ADDENDUM NO. 2

RE: **Athletic Performance Addition**
Perkinston Campus, MGCCC
Perkinston, Mississippi
A/E Project No. 26-028a

FROM: EGH Architects
1091 Tommy Munro Drive
Biloxi, MS 39532
(228) 594-2323

1 DOMESTIC RISER DIAGRAM

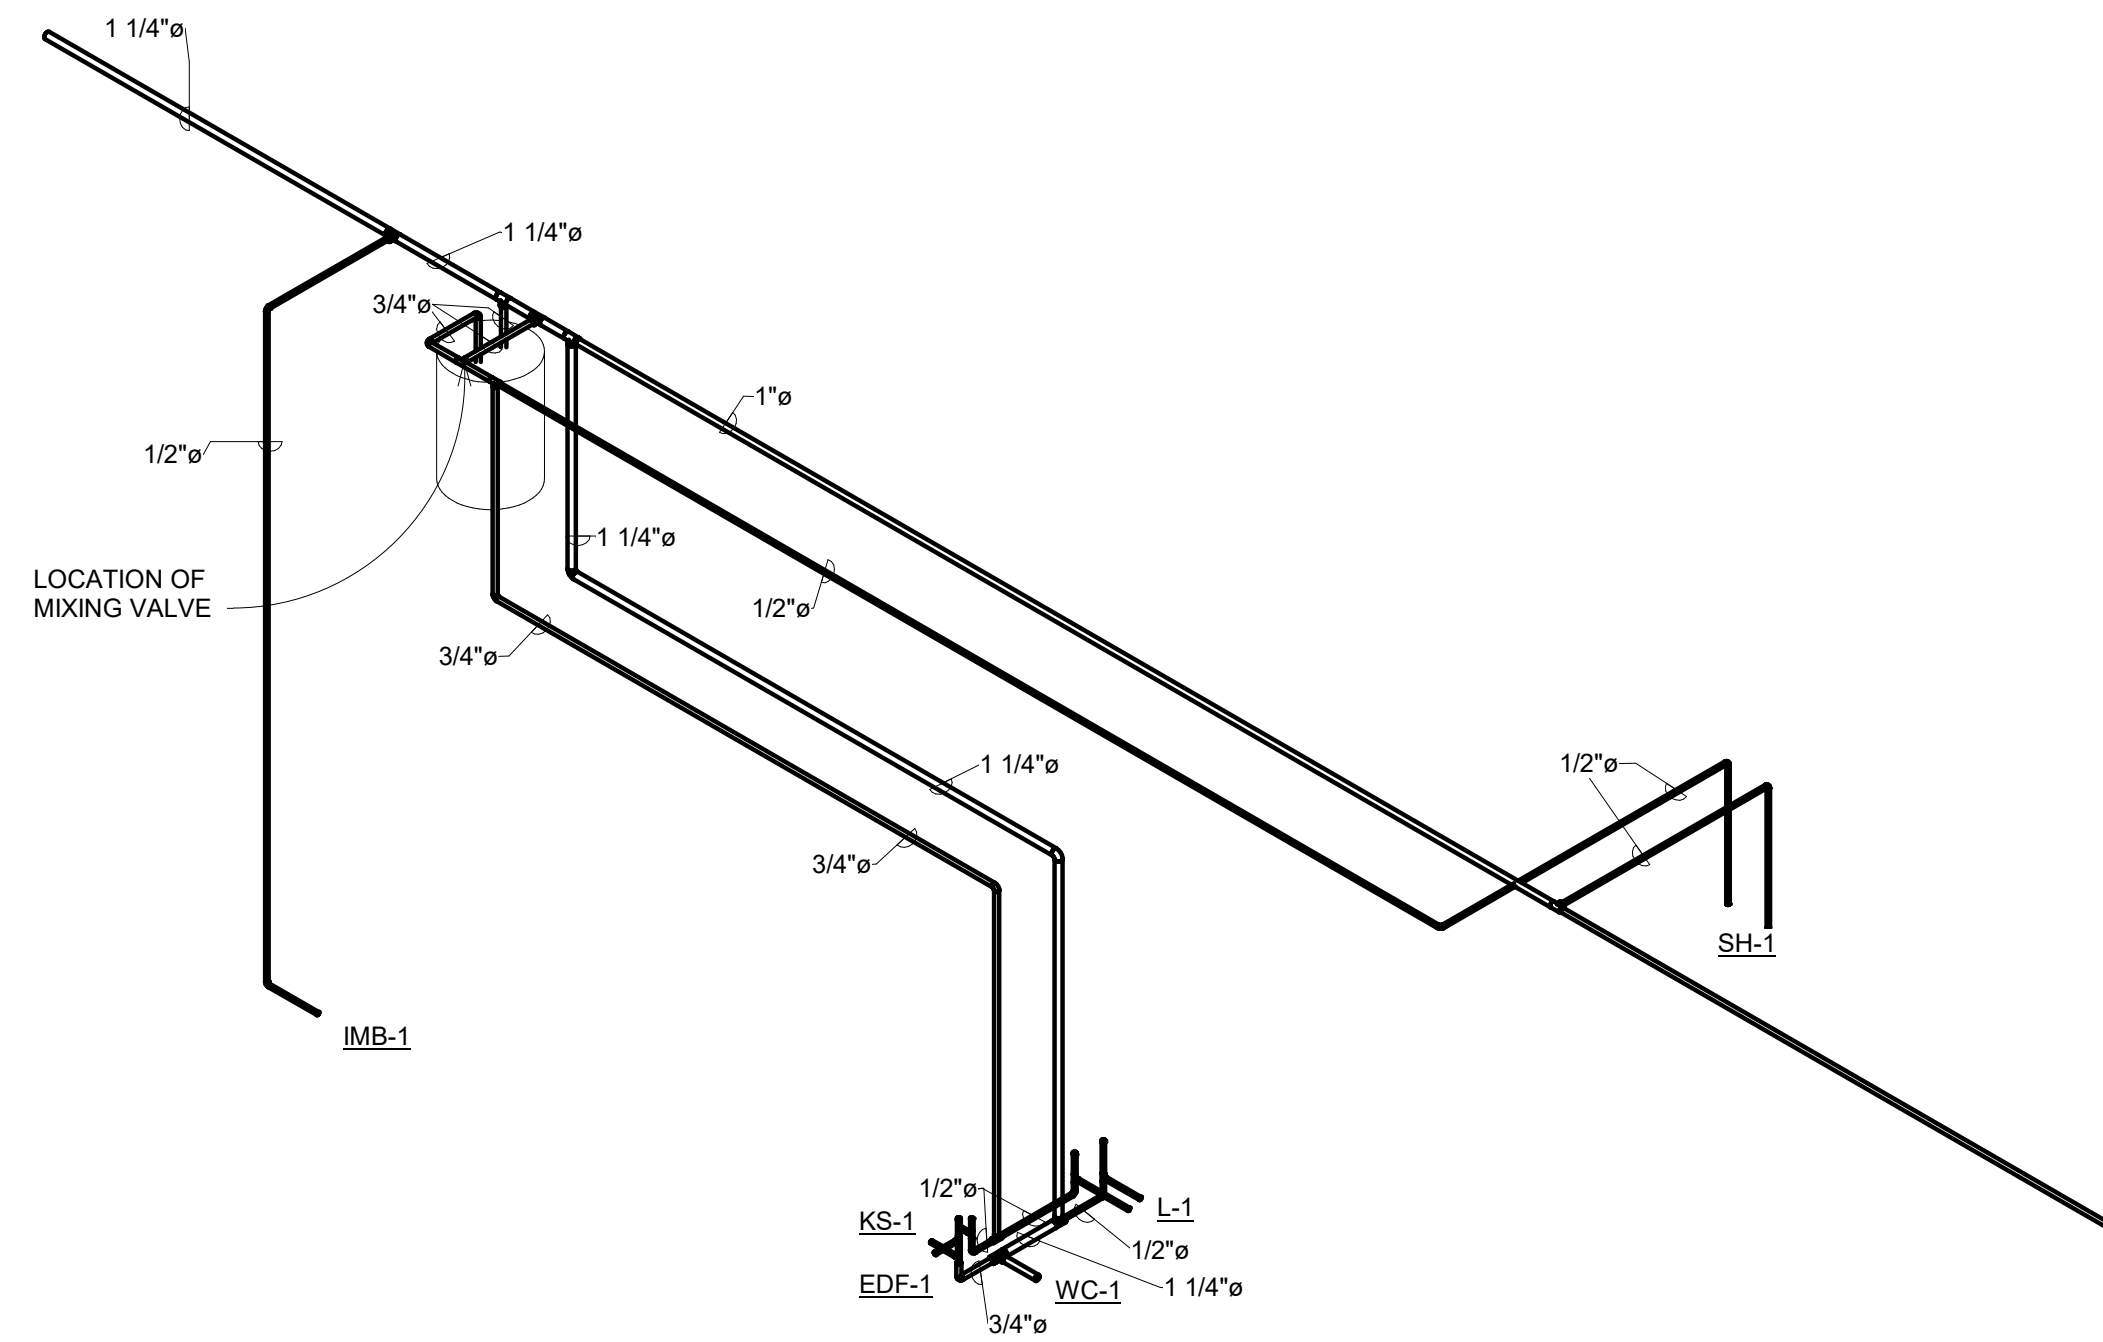
- Sheet added with plumbing riser diagrams.

② HVAC PLAN
3/16" = 1'-0"

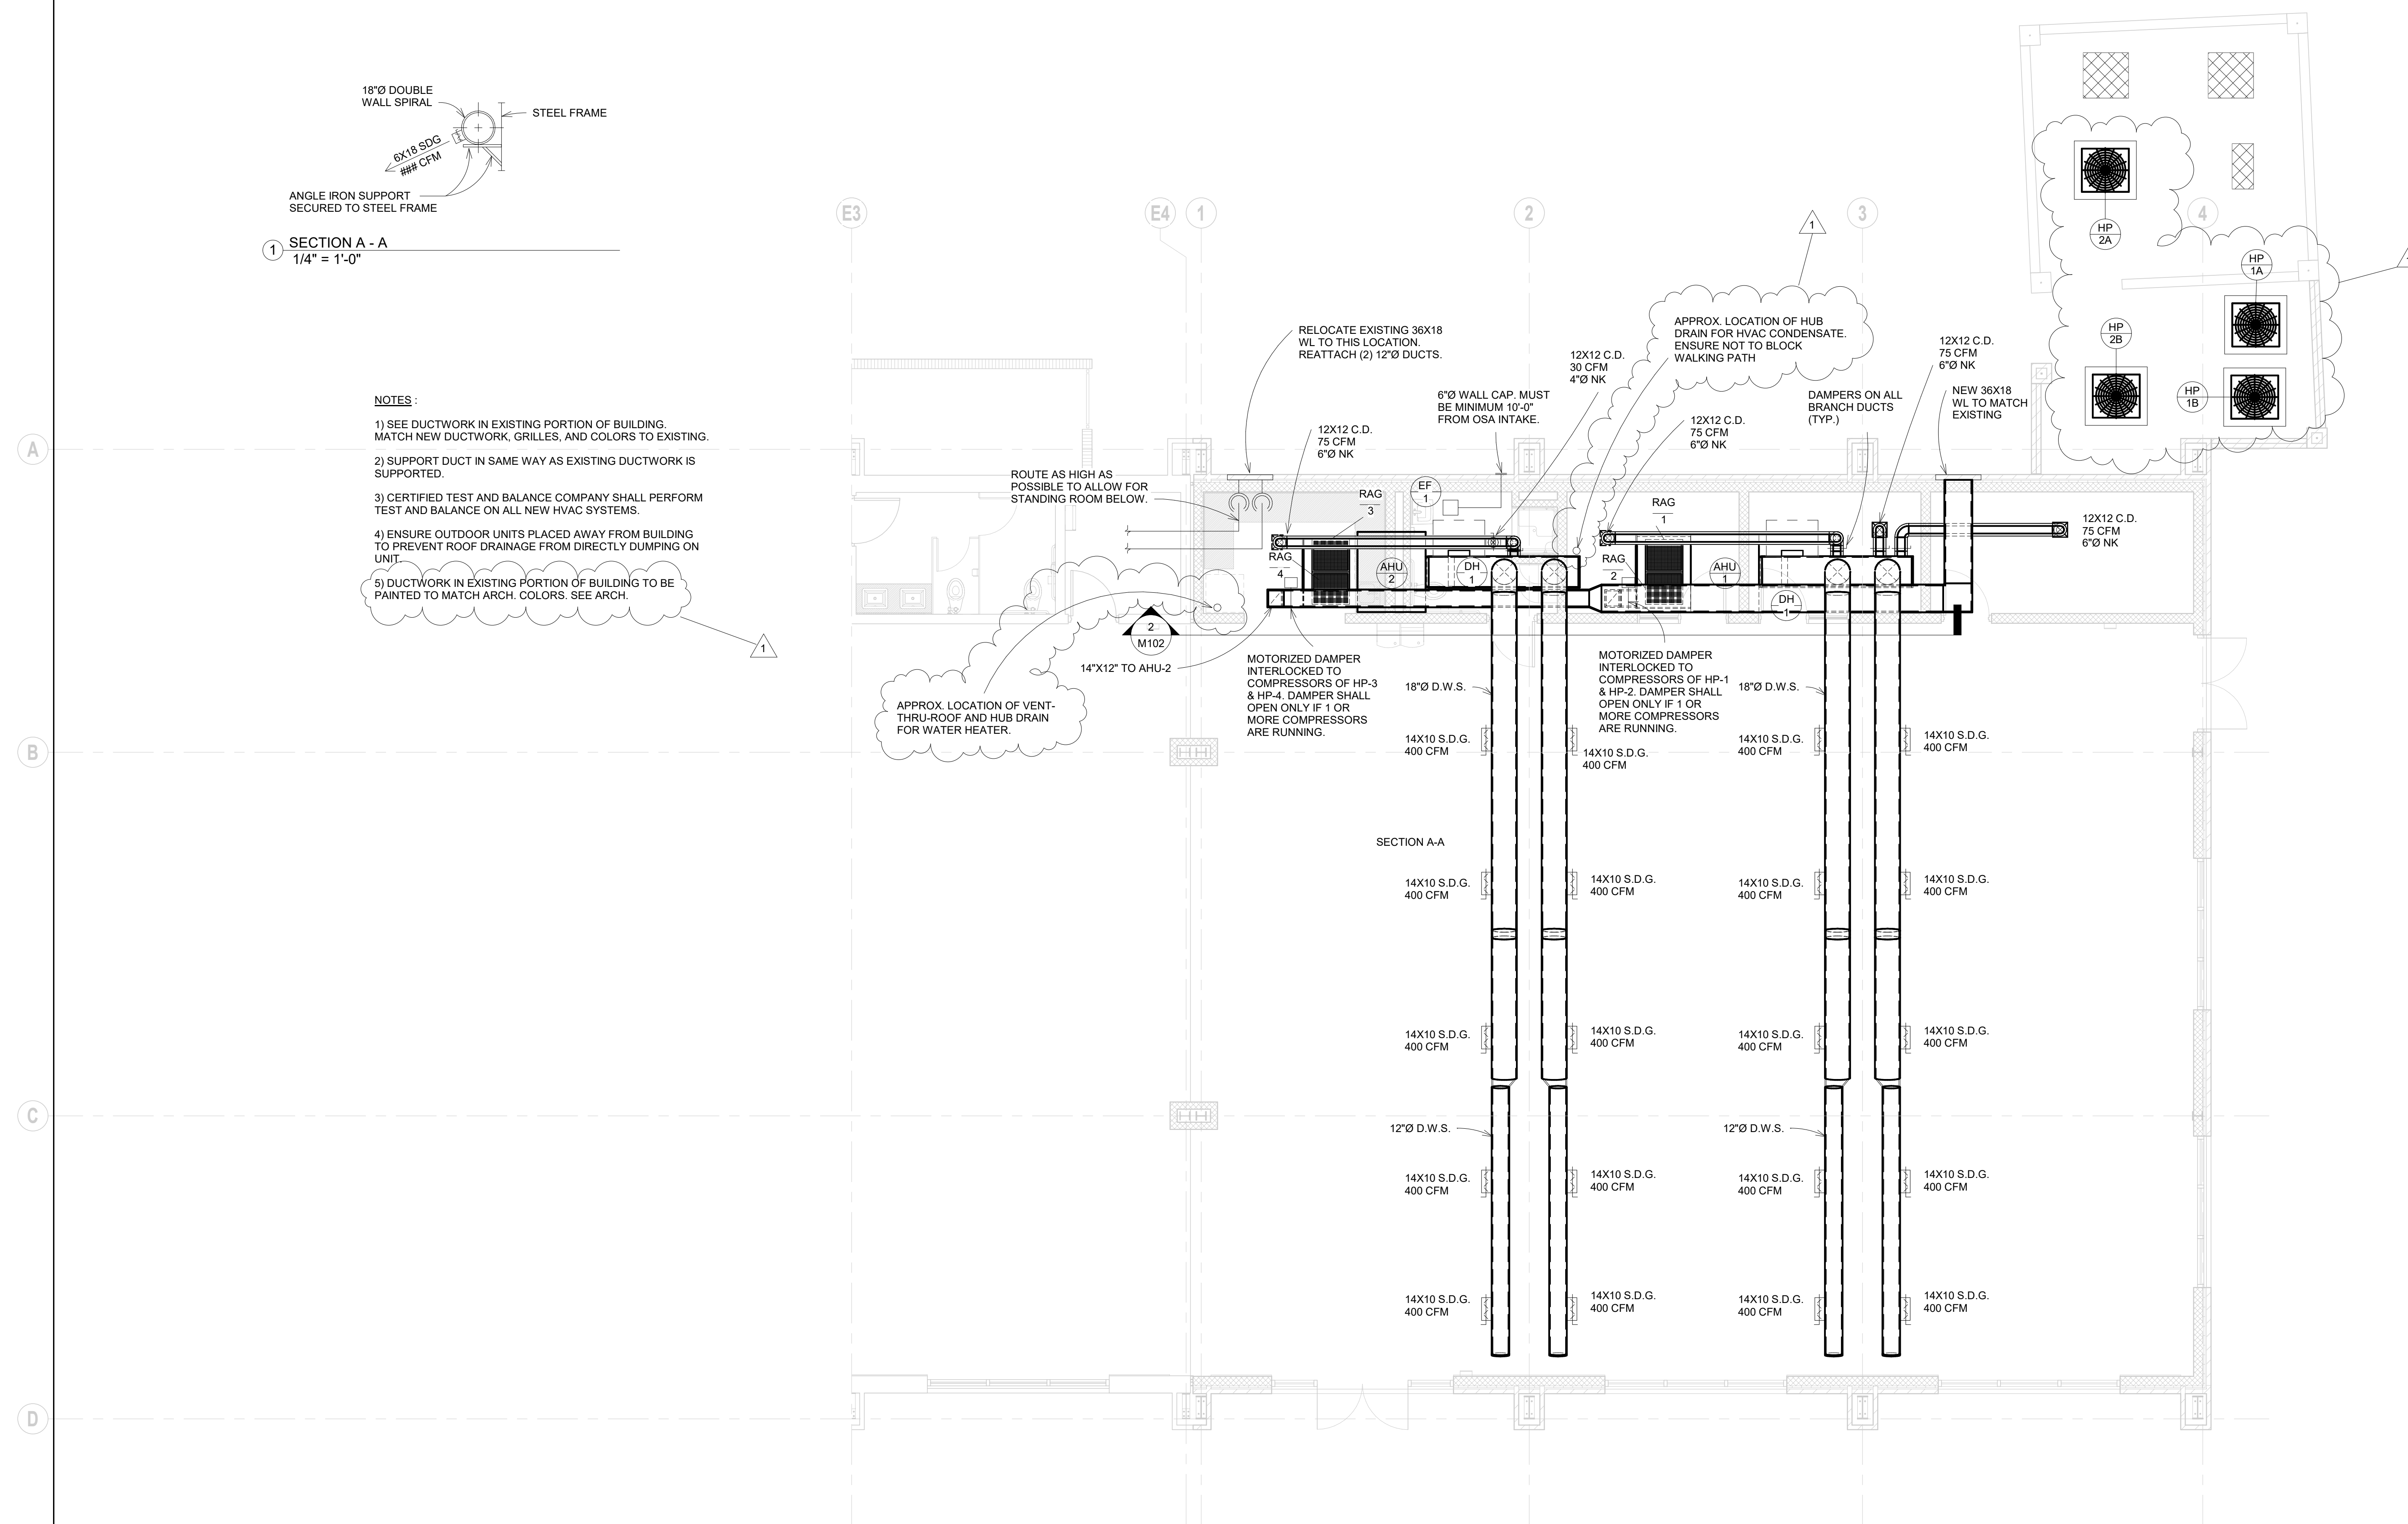
- The spiral round ducts in the existing building shall be painted to match new architectural colors as part of the base bid.
- Heat pumps are renamed to correspond to the air handlers that they are connected to.
- Approximate location of hub drain for HVAC condensate is shown. Ensure not to block walking path.
- Approximate location of VTR is shown for reference.

3 CONTROLS DIAGRAM
1/8" = 1'-0"

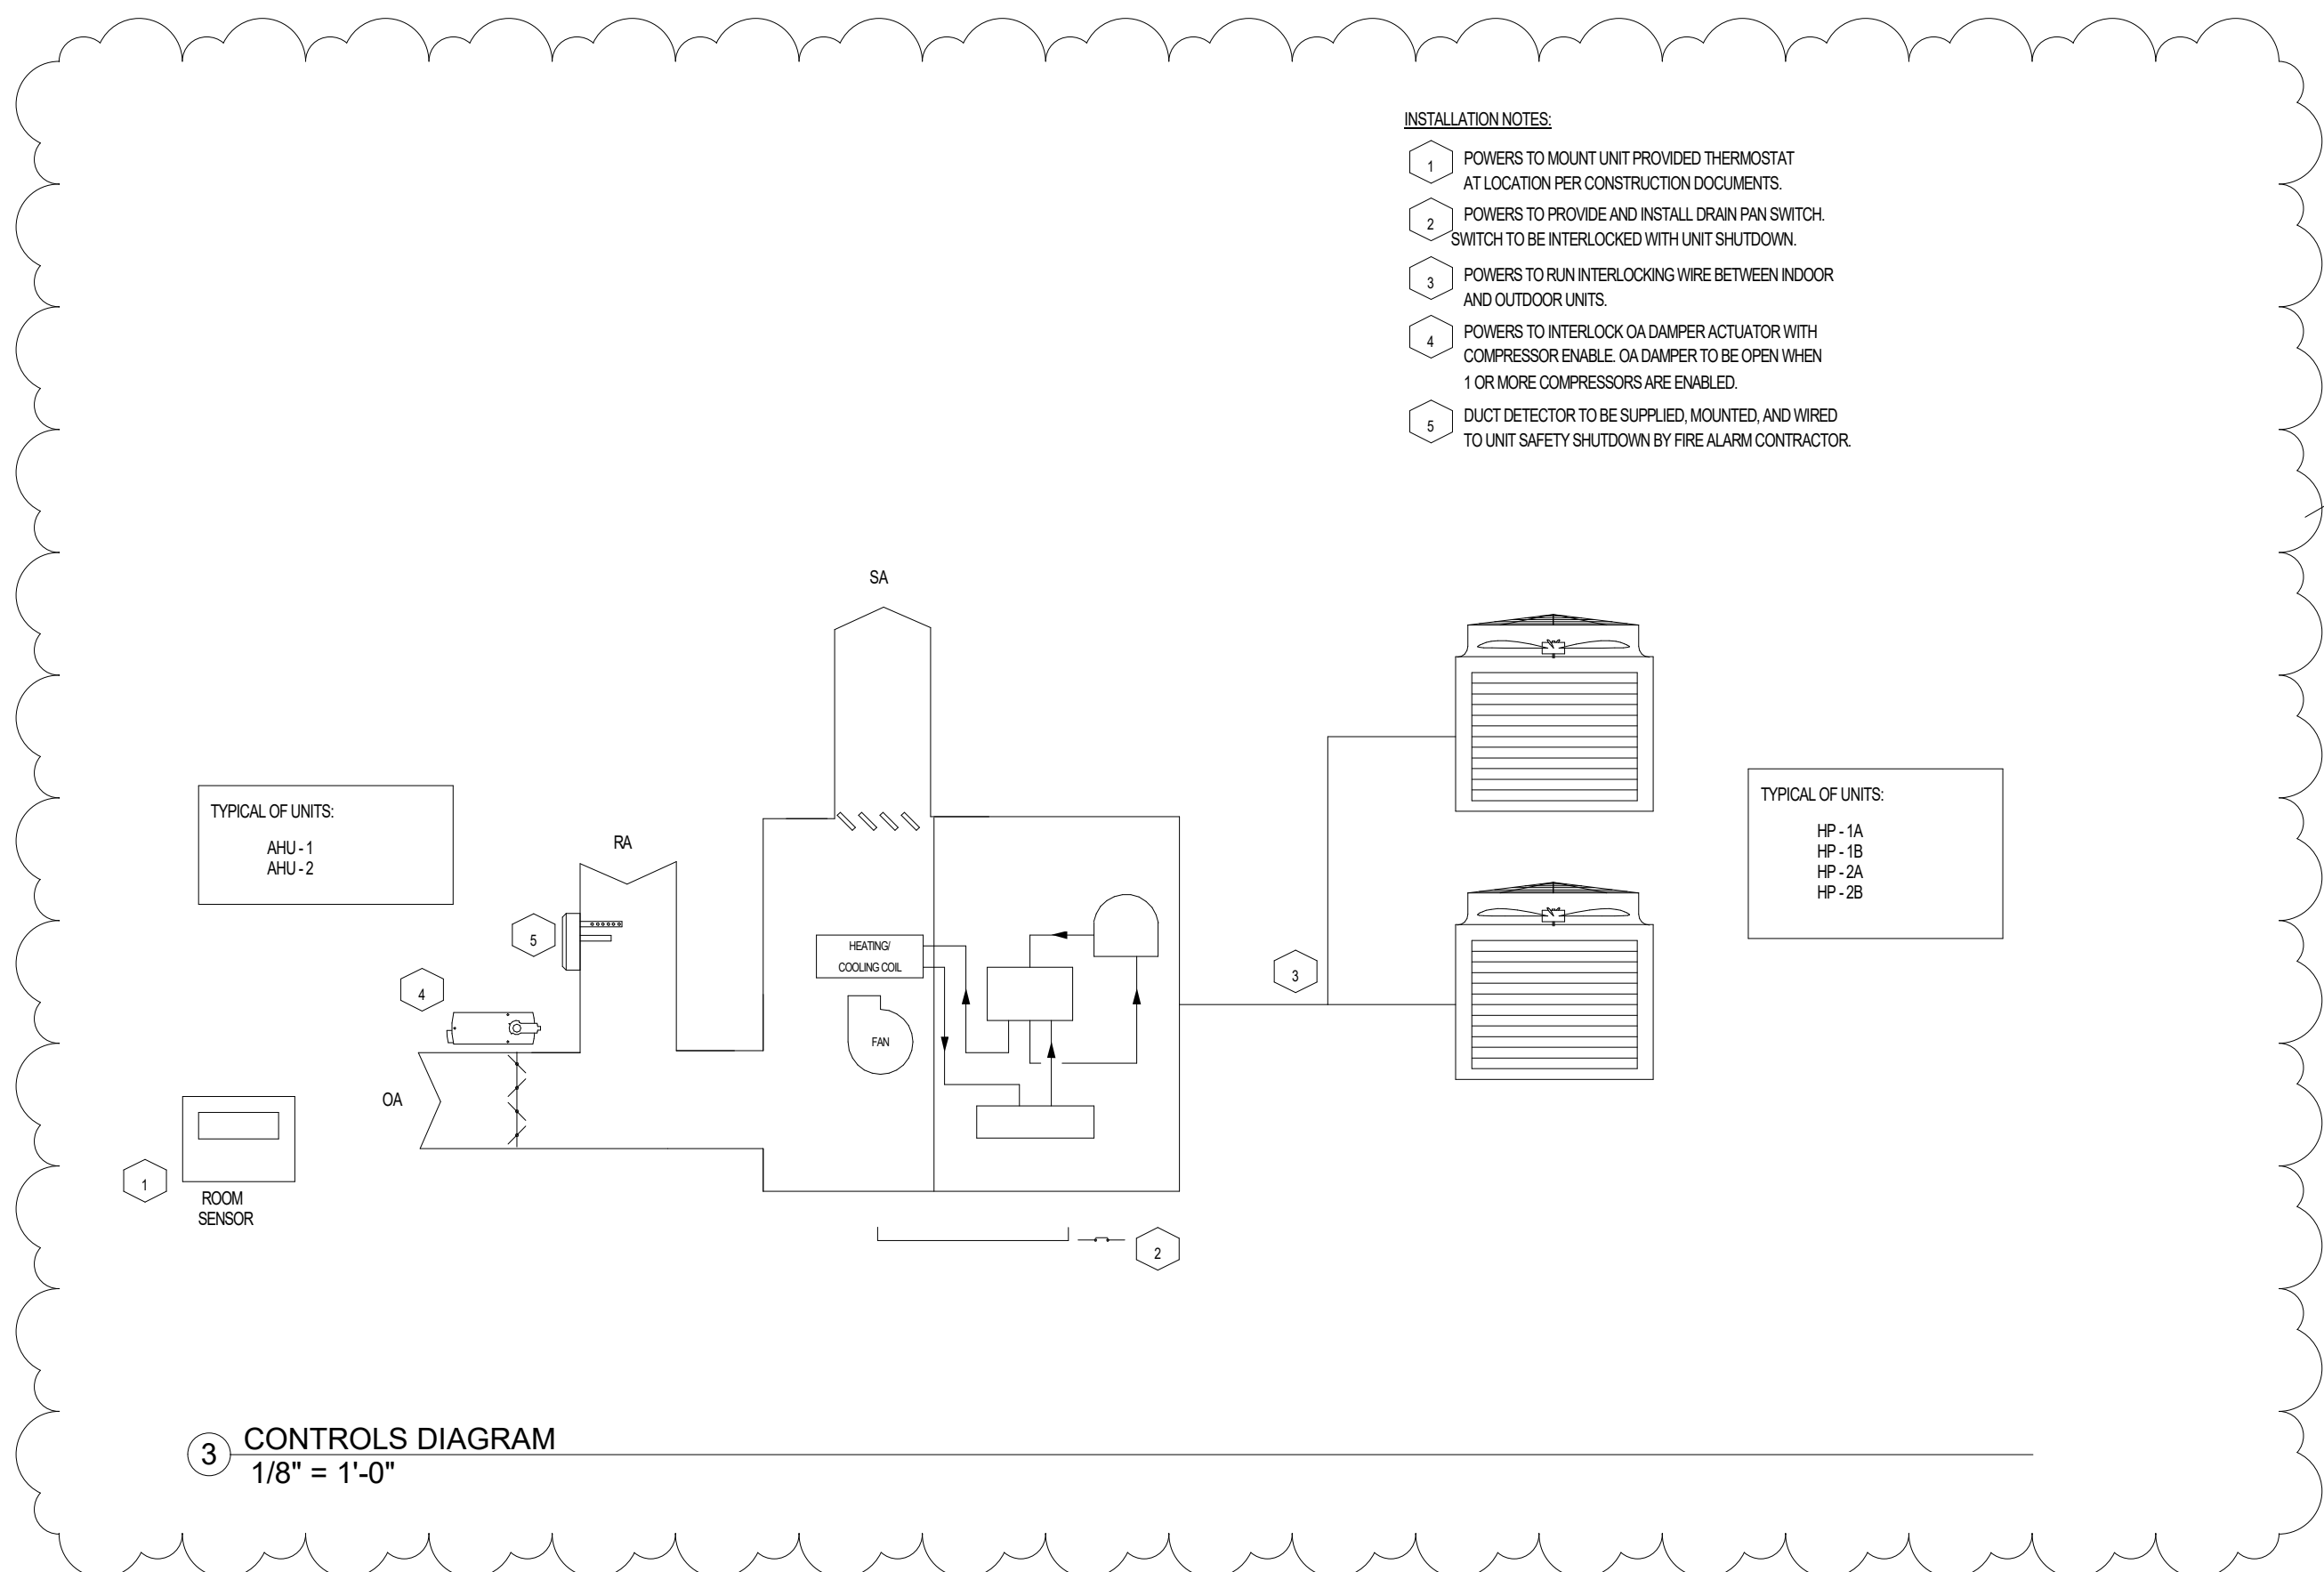
- Refrigerant lines shall be routed around the filter and down through the mezzanine floor. Care should be taken to place the refrigerant lines in such a manner that does not obstruct the walking path or service access to the air handling units.
- Added control wiring diagram.
